# 2006/2007 PROPOSED CHANGES TO THE INTERNATIONAL RESIDENTIAL CODE — BUILDING & ENERGY

## IRC – BUILDING & ENERGY CODE COMMITTEE

**FIGURE R301.1.4(1)**  
**TOPOGRAPHIC FEATURES FOR WIND SPEED UP EFFECT**

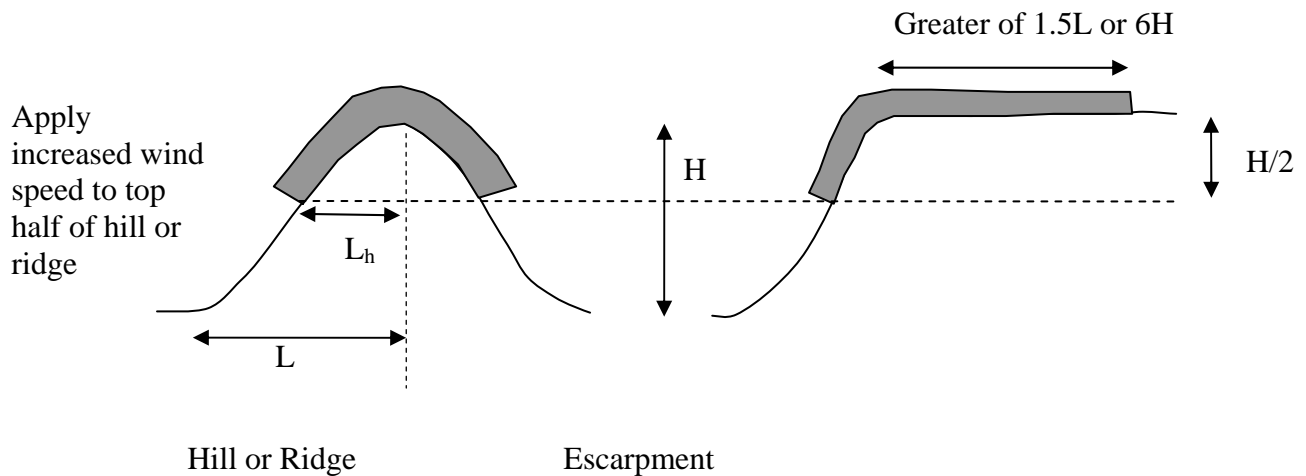
#### 2. Revise as follows:

Buildings sited on the top half of an isolated topographic feature, meeting the following conditions shall be designed for an increased wind basic wind speed as determined by Table R301.2(4):

1. The topographic feature is 60 feet or higher if located in Exposure B or 30 feet or higher if located in Exposures C or D;
2. The average slope of the top half of the topographic feature exceeds 10 percent; and
3. The topographic feature is unobstructed up-wind by other such topographic features for a distance from the high point of 100 times the height of the hill or 2 miles, whichever is less.
4. The topographic feature protrudes above the height of upwind topographic features within a 2-mile radius in any quadrant by a factor of 2 or more.

FIGURE R301.2.2.2(2)1

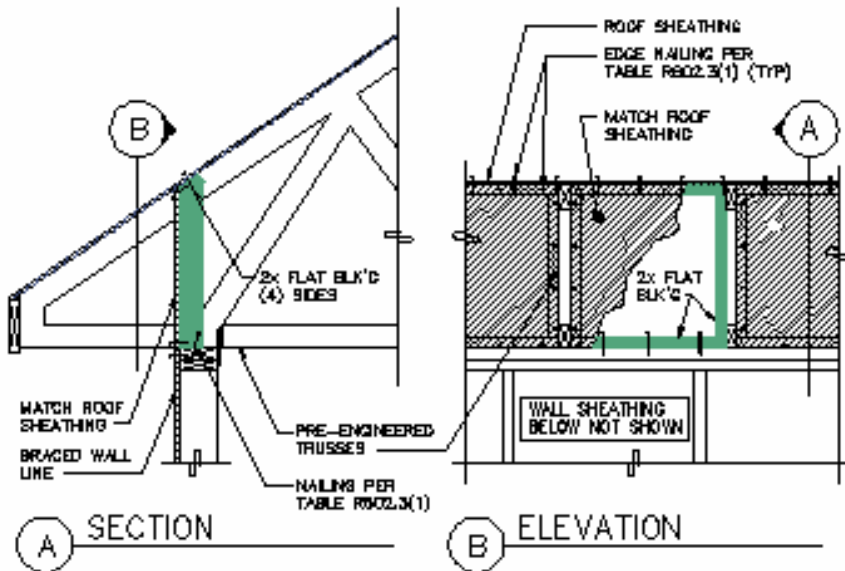
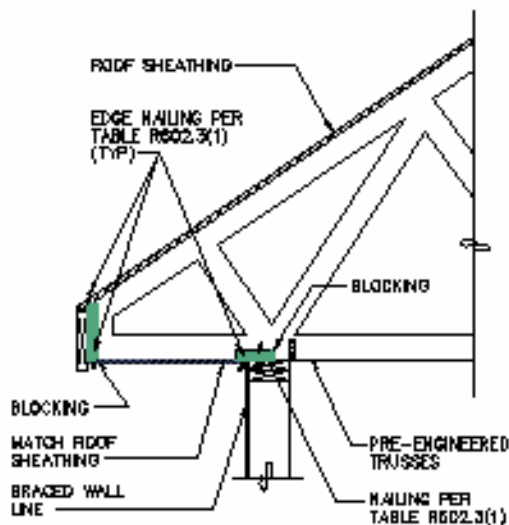
1. Portions of floors that do not support shear walls or braced wall panels above, or roofs, shall be permitted to extend no more than 6 feet (1829 mm) beyond a shear wall or braced wall line.

2. When the floor or roof diaphragm is positively connected to the braced wall line by one of the following methods:
1. Engineered truss blocking for the extent of the wall line designed for 182 plf, or per *Wood Frame Construction Manual for One and Two Family Dwellings*, 2001 Edition, Table A-3.4, and attached to sheathing above and wall below per Table R602.3(1).
  2. Roof or floor diaphragm sheathing above is extended to the braced wall line, for the extent of the wall line, and attached to 2 x 4 minimum blocking with fasteners per Table R602.3(1) . (See Figures R301.2.2.2(2)1 and R301.2.2.2(2)2.)
  3. Connected in a manner approved by the building official.

**FIGURE R307.1  
MINIMUM FIXTURE CLEARANCES**

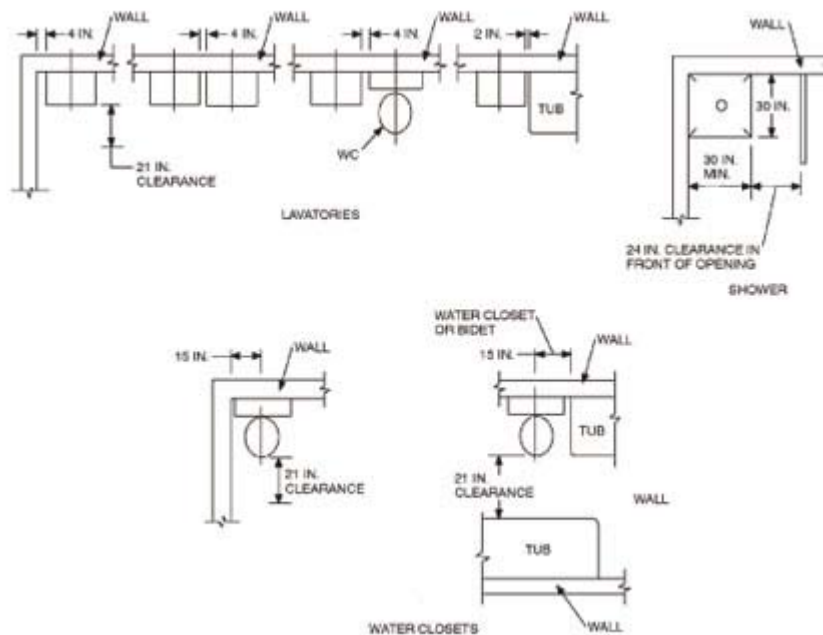
**Revise figure as follows:**

**Reason:** According to the *International Residential Code* commentary, the figures in R307.1 are necessary to make fixtures accessible and usable. Unfortunately, the side wall and fixture to fixture clearance requirements for lavatories greatly reduces the ability of homeowners and builders to use the wide variety of lavatory types and styles available in today's marketplace. If the purpose of Figure R307.1 is for disabled accessibility and usability, then clearance requirements should be based on those in ICC/ANSI A117.1.

The drawings in figure R307.1 do not indicate if these are wall mounted or free standing fixtures, or installed in the countertops of vanities, or kitchen cabinets, or all of the above. In addition; the drawings do not indicate if the clearance requirements are to edge of the fixture or to the edge of the bowl making this section of the code especially difficult to interpret and enforce.

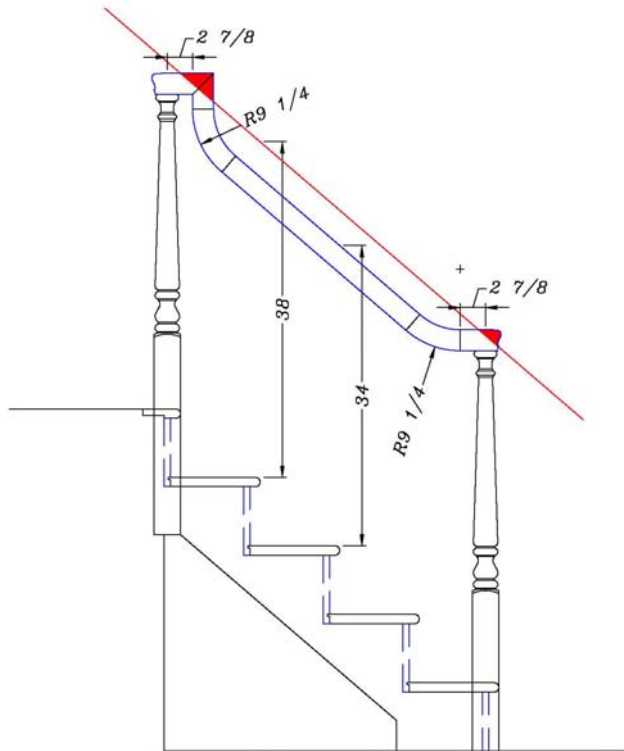
**R311.5.6.1 Height.** Handrail height, measured vertically from the sloped plane adjoining the tread nosing, or finish surface of ramp slope, shall be not less than 34 inches (864 mm) and not more than 38 inches (965 mm).

1. The use of a volute, turnout, or starting easing shall be allowed over the lowest tread.
2. When handrail fittings are used to provide continuous transition between flights, the transition from handrail to guardrail, or used at the start of a flight, the handrail height at the fitting shall be permitted to exceed the maximum height.

**Reason:** To add additional language required The proposal will make exception for minor variances in height that have been noted when starting fittings permitted to interrupt the rail are used and allow height exception for gooseneck fittings when fittings are used to provide continuity.

FIGURE 1 – CANTILEVERED BUILDING

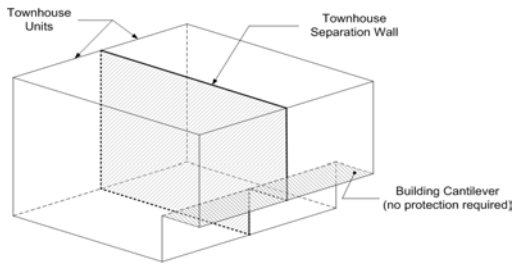
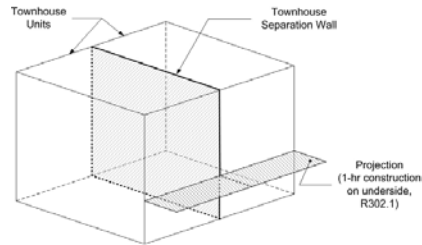
**Reason:** The purpose of this proposal is to clarify code requirements for townhouse designs in which upper stories overhang lower stories. The IRC doesn't explicitly address this type of design. Section R317.2.1 requires that common walls between townhouses be continuous from foundation to roof, but doesn't explain how that provision applies where portions of the townhouses are cantilevered. Figure 1 illustrates a common townhouse configuration, and shows the protection that is required by this proposal. Garage doors are often located in the wall below the overhang; living spaces are located in the overhanging area.

Cantilevers should be protected at least as much as projections. Projections such as balconies, located 4 feet or less from an adjoining townhouse must be protected by one-hour construction on the underside. (Section R302.1) Cantilevered overhangs are usually occupied floor area, often bedrooms, and need at least as much protection as balconies which typically are much less heavily occupied. Figure 2 shows a projection from a townhouse that must be protected with one-hour construction. The risk of fire spreading from the garage into the overhang presents a much greater hazard than the risk posed by the projection.
